**Dye Branch II
Stream Restoration
MY7 Monitoring Report (2018)
NCDMS Project Number: 92255**

**Submitted to
North Carolina Division of Mitigation Services
North Carolina Department of Environmental Quality
November 2018**

Subject: Dye Branch Stream Restoration Project #92255 – 2018 MY7 Monitoring Report Comments

Figure 2. Integrated Current Condition Plan View

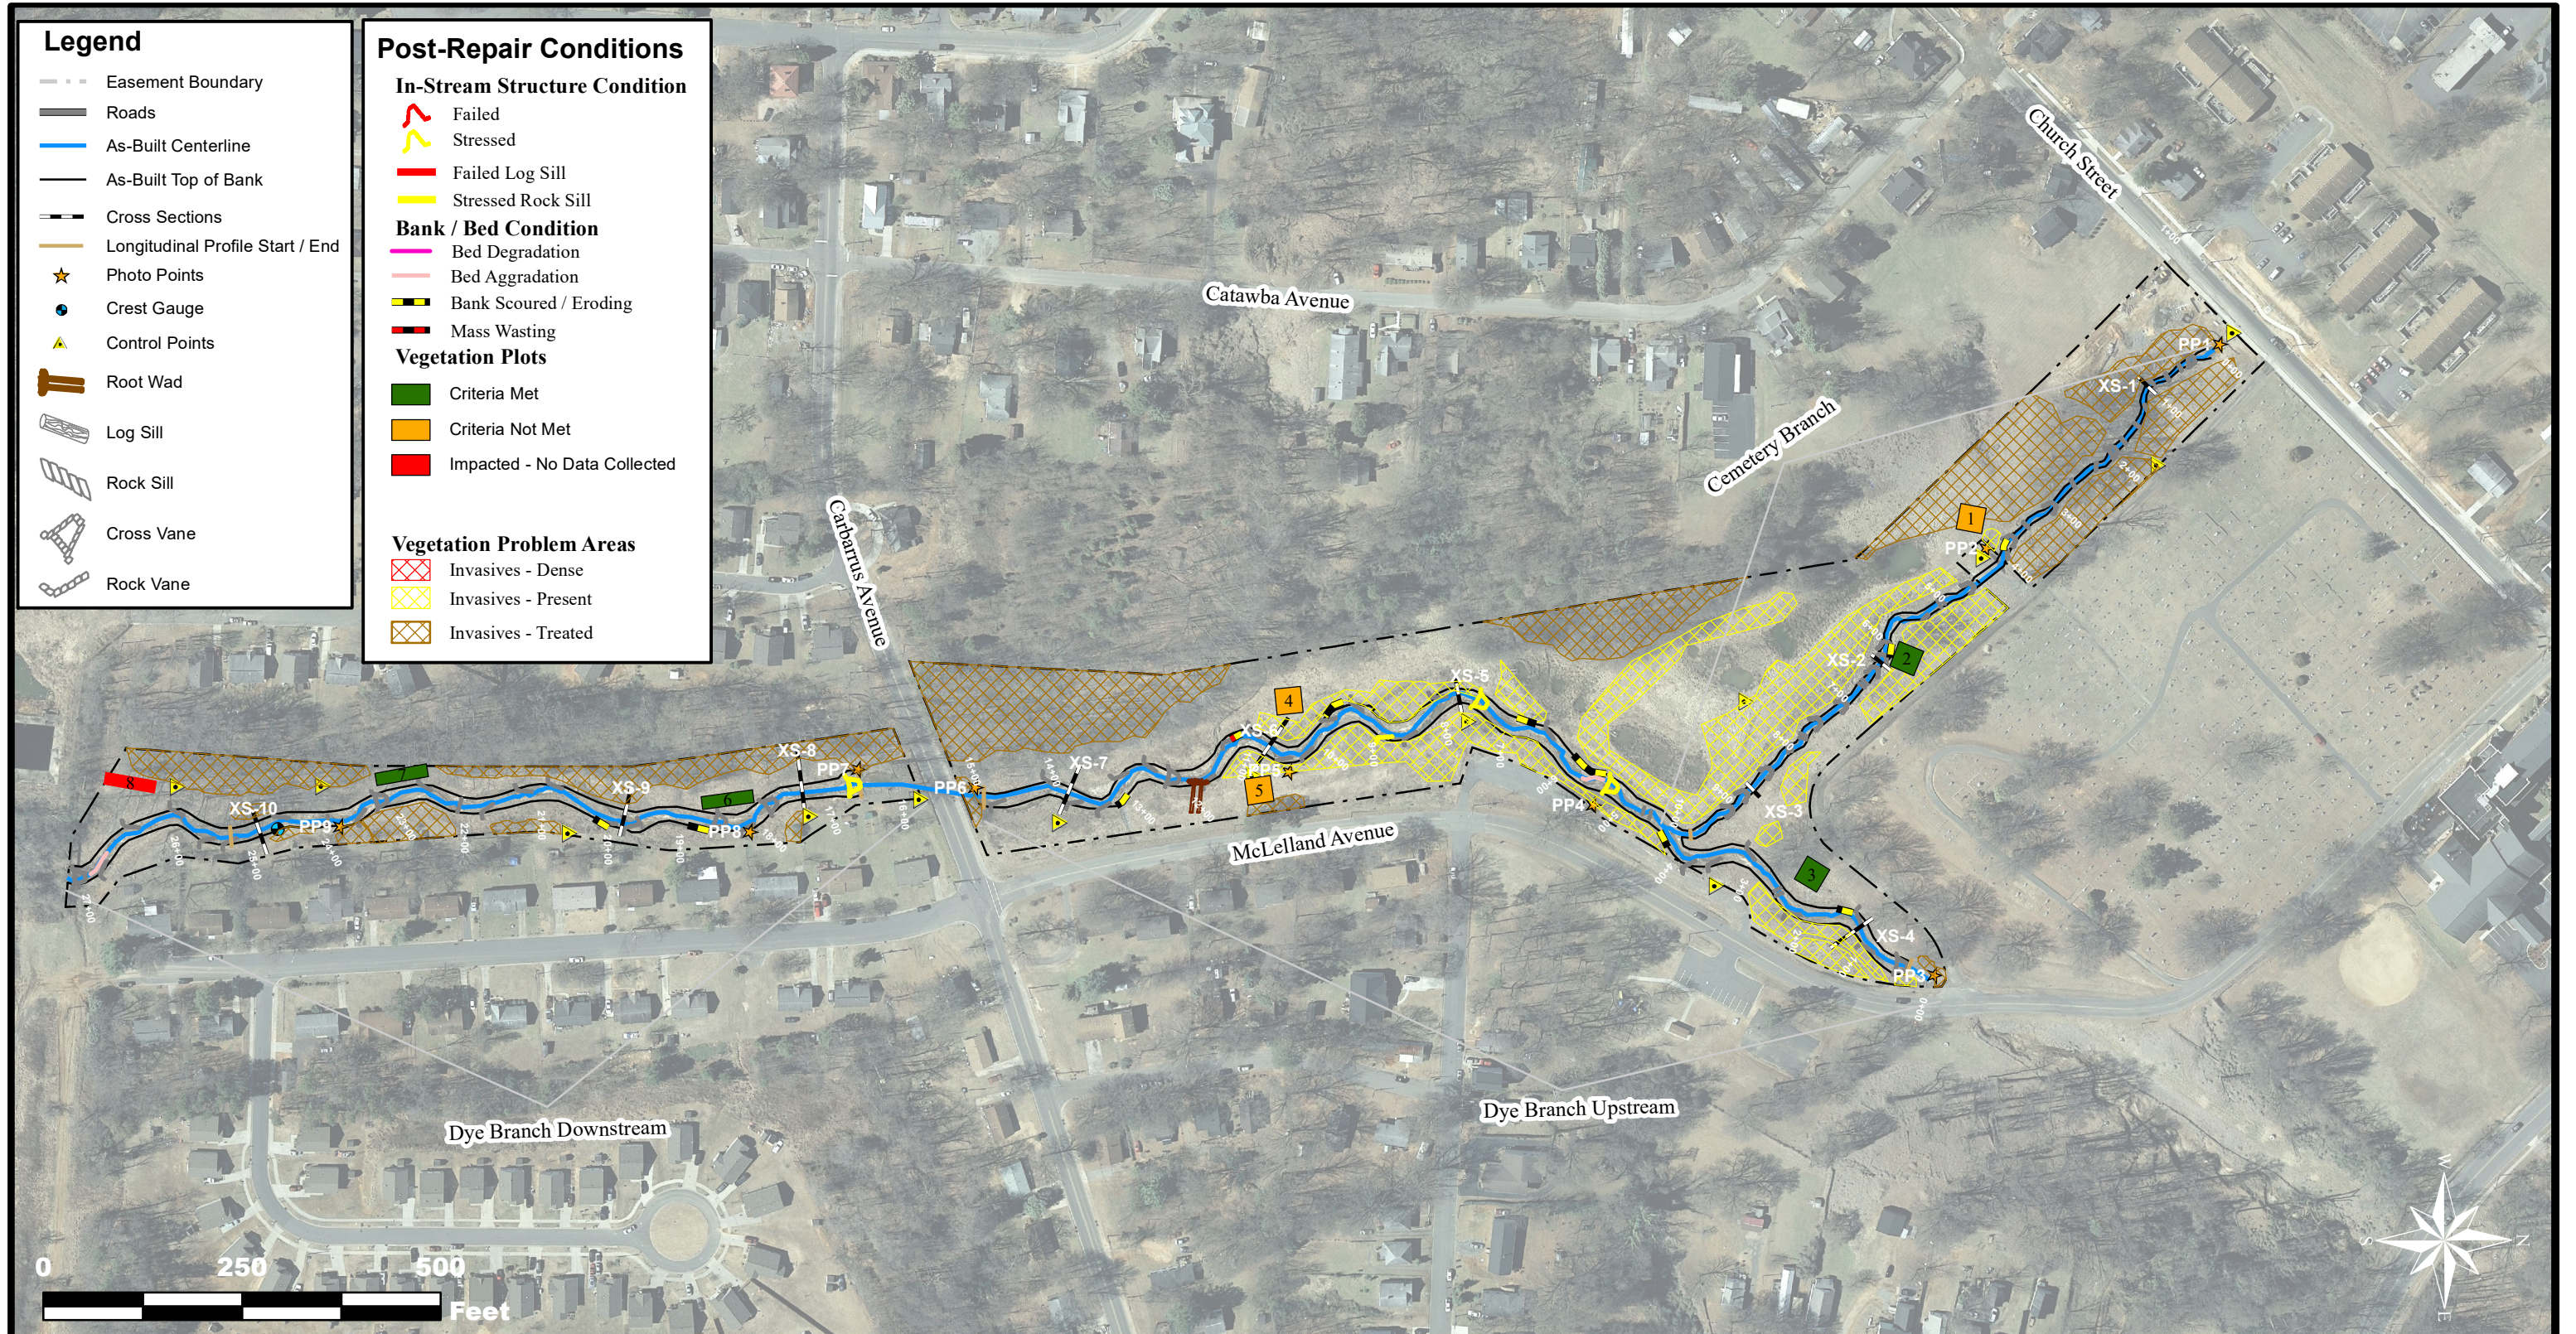
- Please update title to “Monitoring Year 7 – Integrated Current Condition Plan View”. **The title of the CCPV has been updated to reflect Monitoring Year 7.**
- Please include a call out for the planted/ total stems for vegetation plots (ex: 260/1100) and update legend. **Call outs for the planted and total stems for vegetation plots has been added to the CCPV and the legend has been updated.**
- Please add locations of the 4 temporary plots and include call out for total stems. **The 4 temporary vegetation plots have been added to the CCPV along with call outs for total stems.**

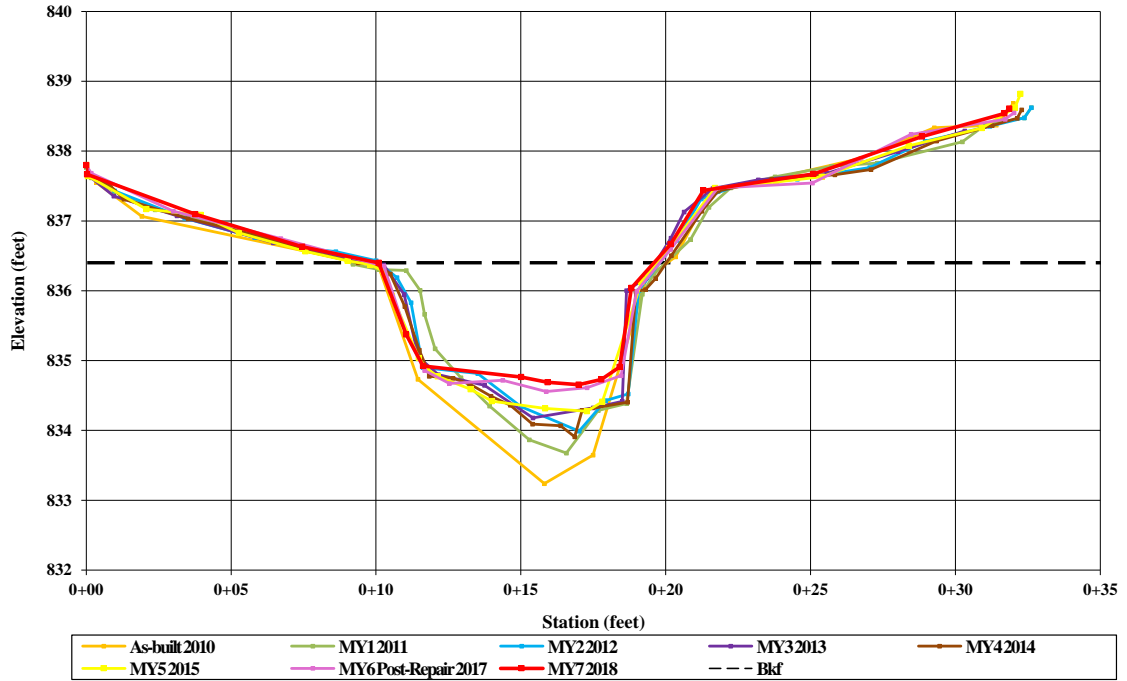
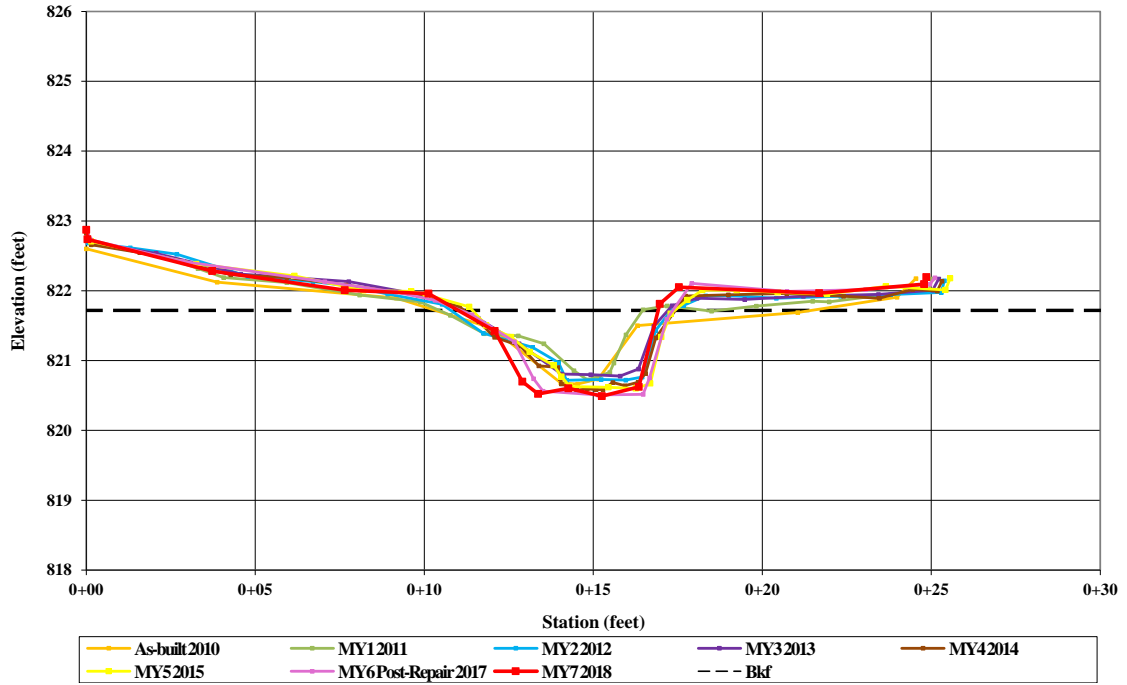
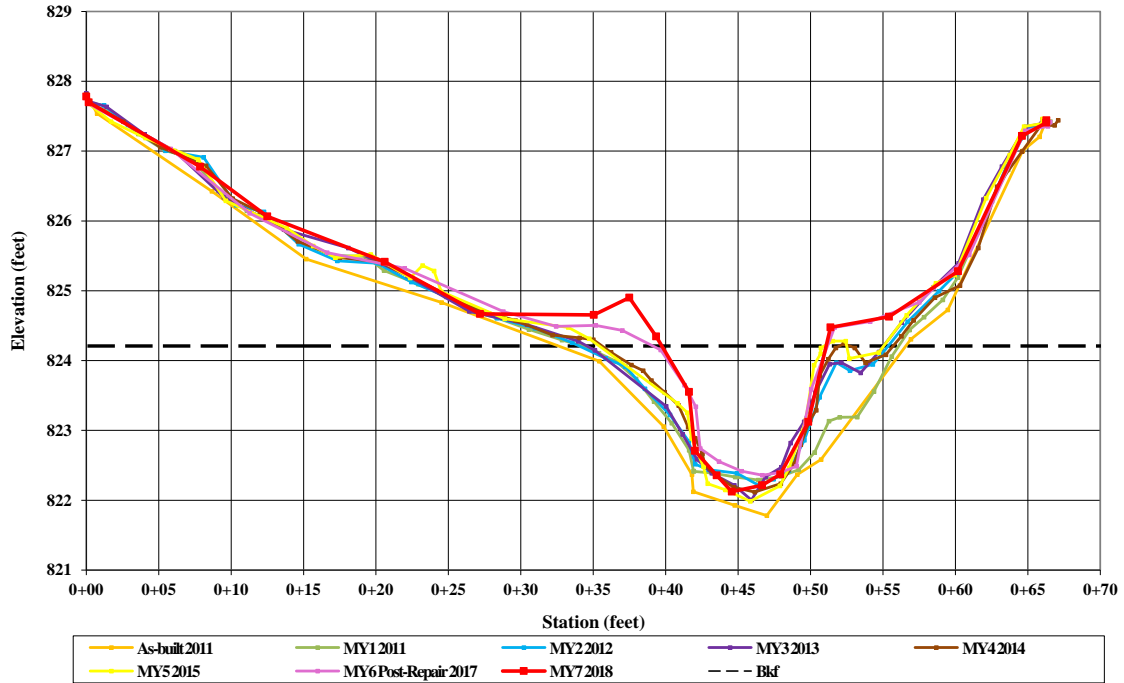
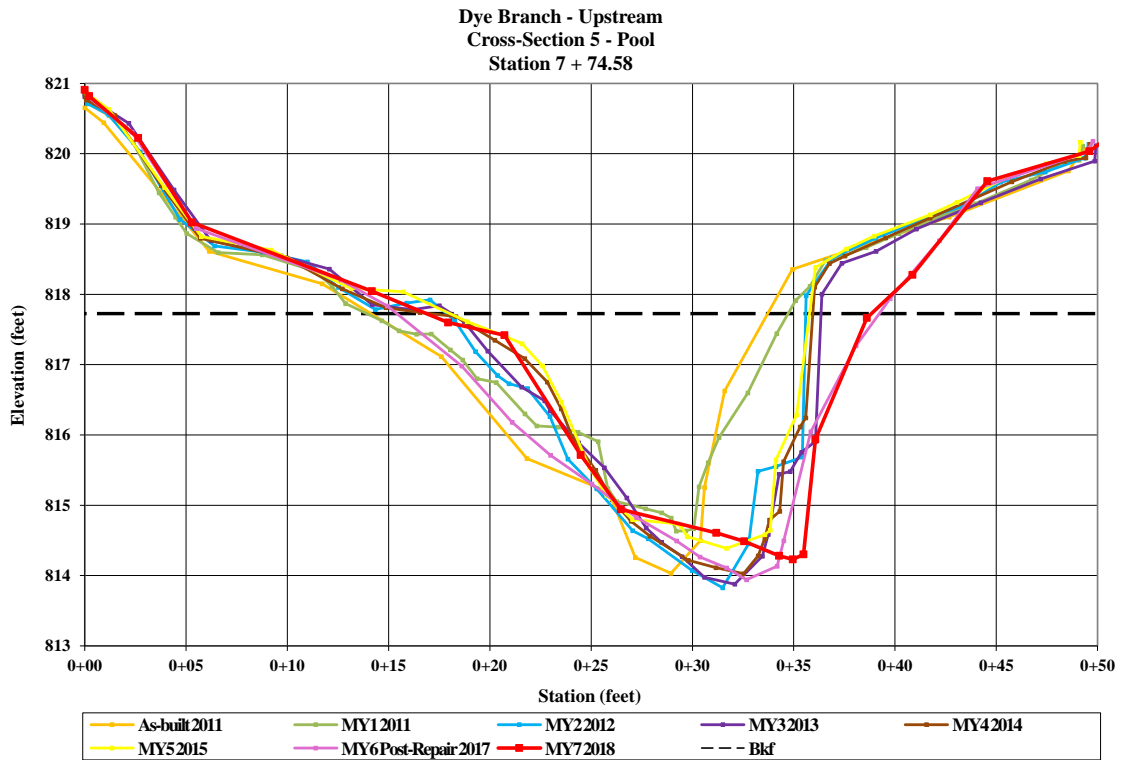
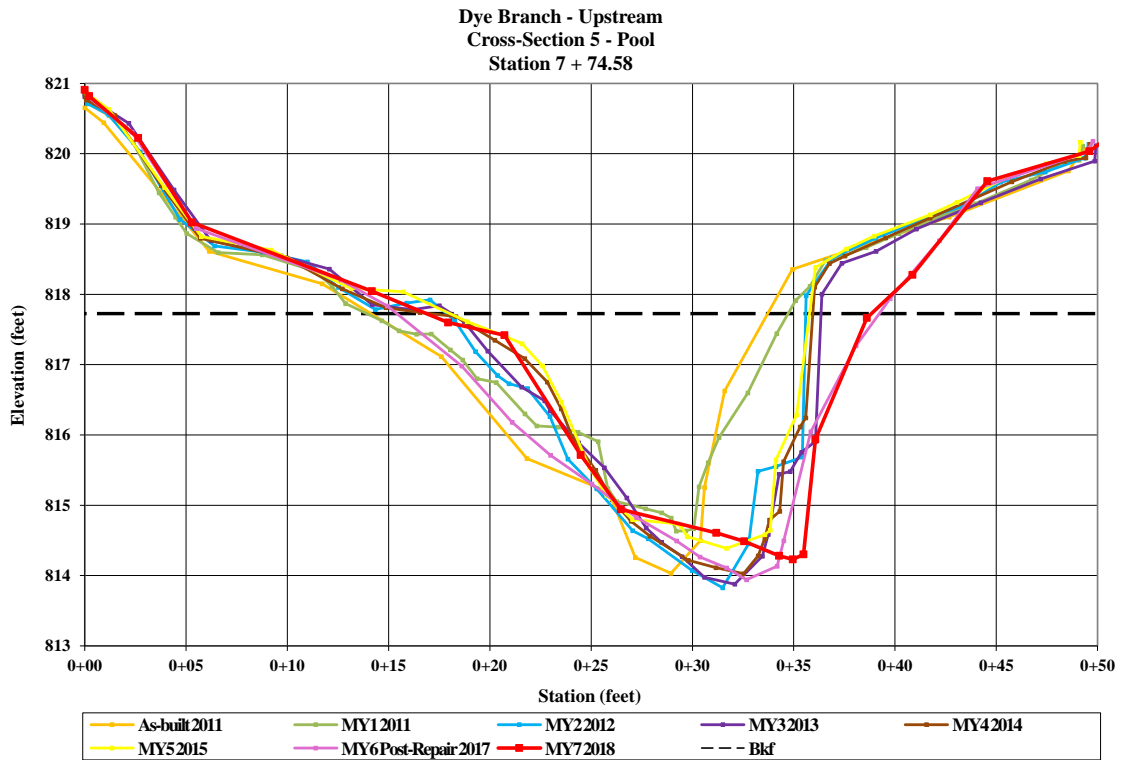
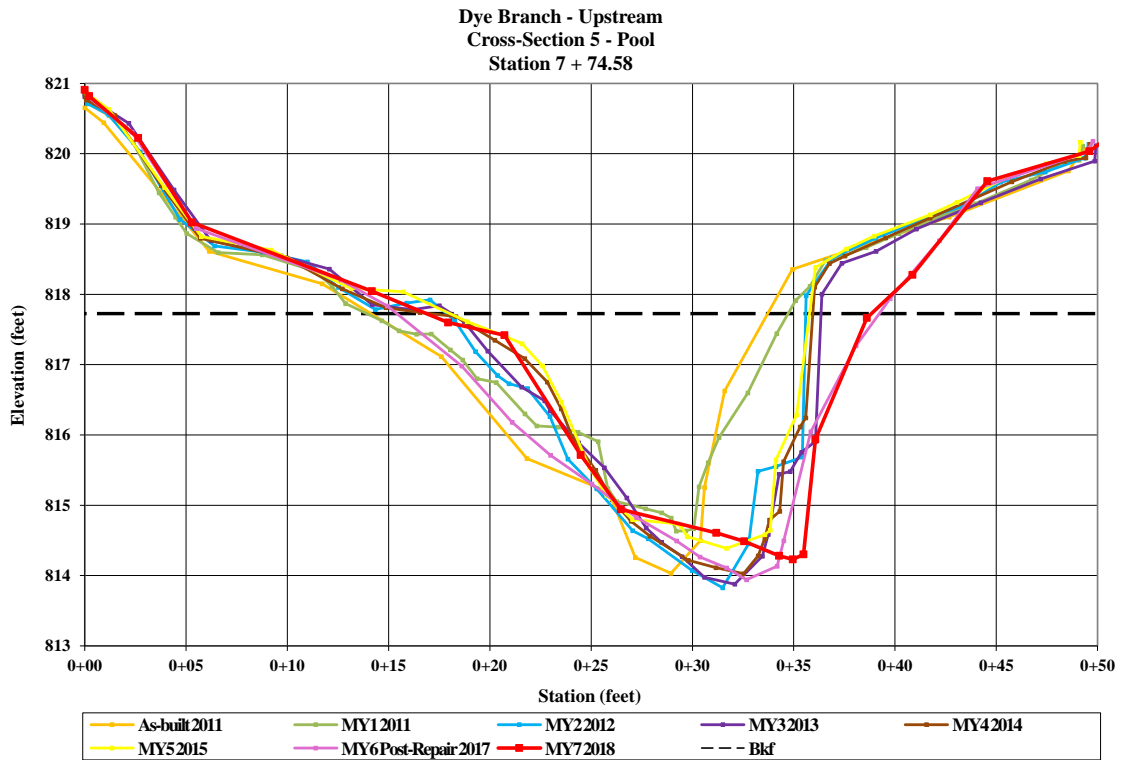
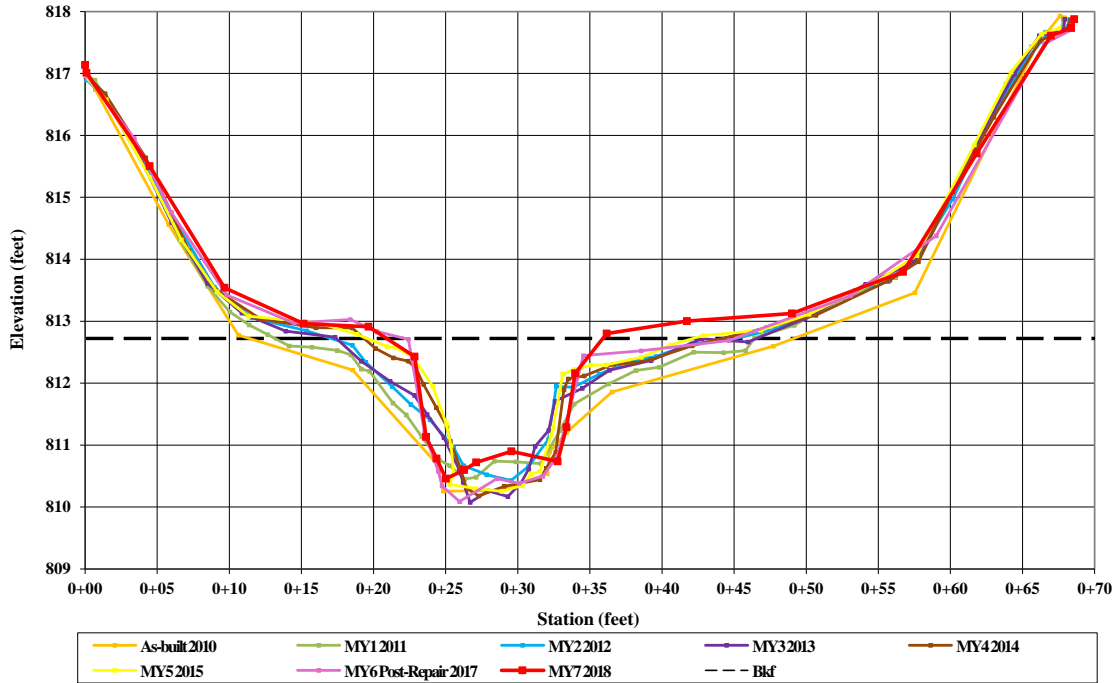
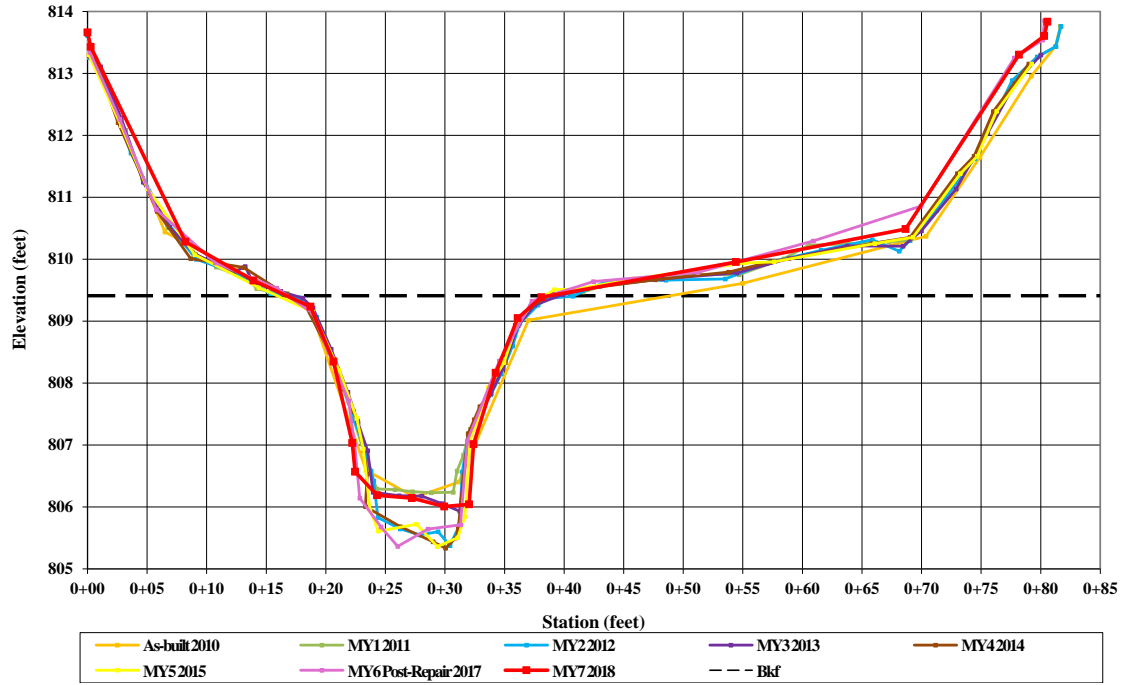
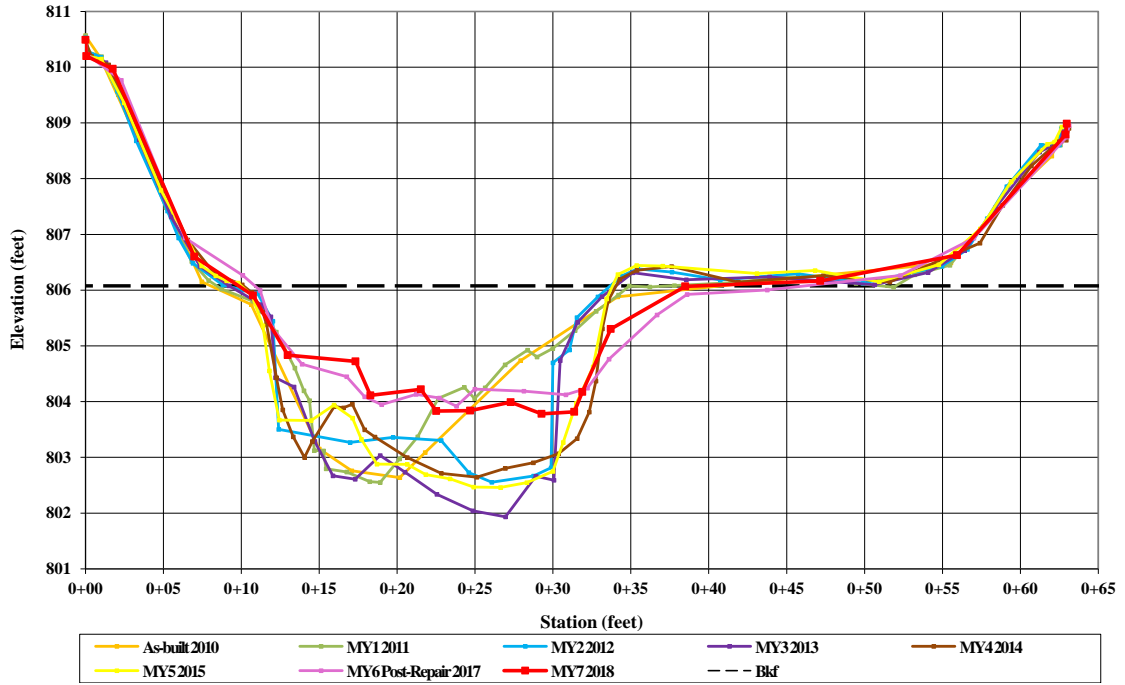
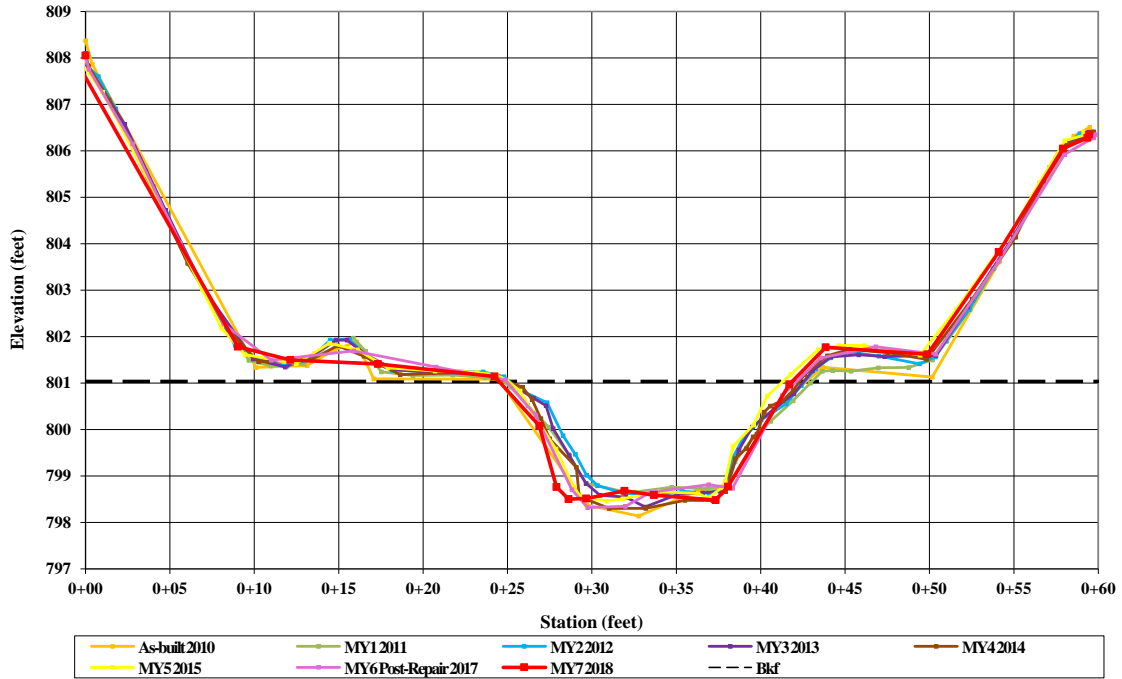
- Please add “MY6” before “Post Repair 2017” and change “MY6 2018” to “MY7 2018” in legend. **“MY6” has been added before “Post Repair 2017” and “MY6 2018” has been changed to “MY7 2018” in the legend of the cross section overlays.**
